UNITED STATES PATENT AND TRADEMARK OFFICE

APPLICATION NO.	FILING DATE	FIRST NAMED INVENTOR	ATTORNEY DOCKET NO.	CONFIRMATION NO.
10/522,507	01/17/2006	Igor Pereverzev	19339-100309	3456

Office Action Summary	Application No. 10/522,507	Applicant(s) PEREVERZEV, IGOR	
	Examiner KRISTINA R. FULTON	Art Unit 3673

DETAILED ACTION

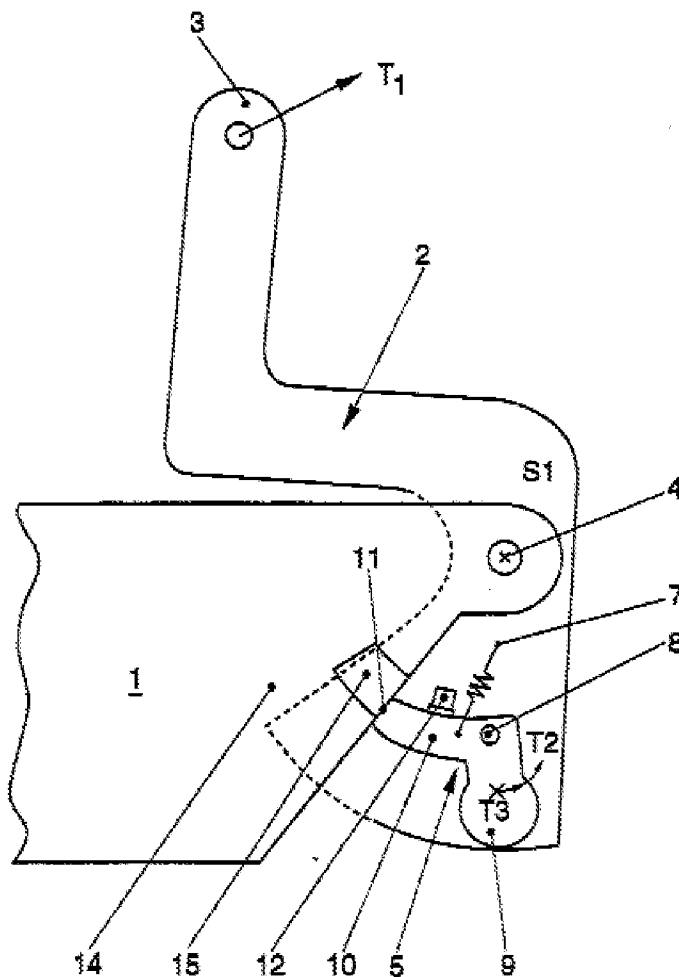
4. Regarding claim 1, Koeppen shows a latch mechanism for selectively latching a door to an automotive vehicle, said latch mechanism comprising a latch hook (see abstract; locking mechanism) movable between a locked position and an unlocked position, a release lever (1) operatively coupled to said latch hook for selectively moving said latch hook between said locked and unlocked positions; and an inertia lever (2) engageable with said release lever to prevent movement of said latch hook between said locked and unlocked positions, said inertia lever movably supported within said latch mechanism for moving in and out of engagement with said release lever in response to a side impact upon the vehicle (see abstract for explanation of motion

relative to change in acceleration); wherein said release lever includes a slot (15) presenting sides for engaging a portion of said inertia lever for automatically toggling said inertia lever in response to movement of said release lever to prevent seizing of said inertia lever within the latch mechanism. See the Koeppen device below.

5. Regarding claim 2, Koeppen shows a means for biasing (7) the inertia lever to a first position out of engagement with said release lever.

6. Regarding claim 3, Koeppen shows the inertia lever has a tab (11) and said slot of said release lever is aligned with and engages the tab when the release lever is actuated to unlock the latch hook and the inertia lever is in the first position (see figure 2 where 11 is in 15 allowing rotation).

7. Regarding claim 4, side impact moves the inertia lever to a second position (figure 3) so that the tab and slot are not aligned.

8. Regarding claim 5, the inertia lever is pivotally mounted within said latch mechanism (pivot point T1).
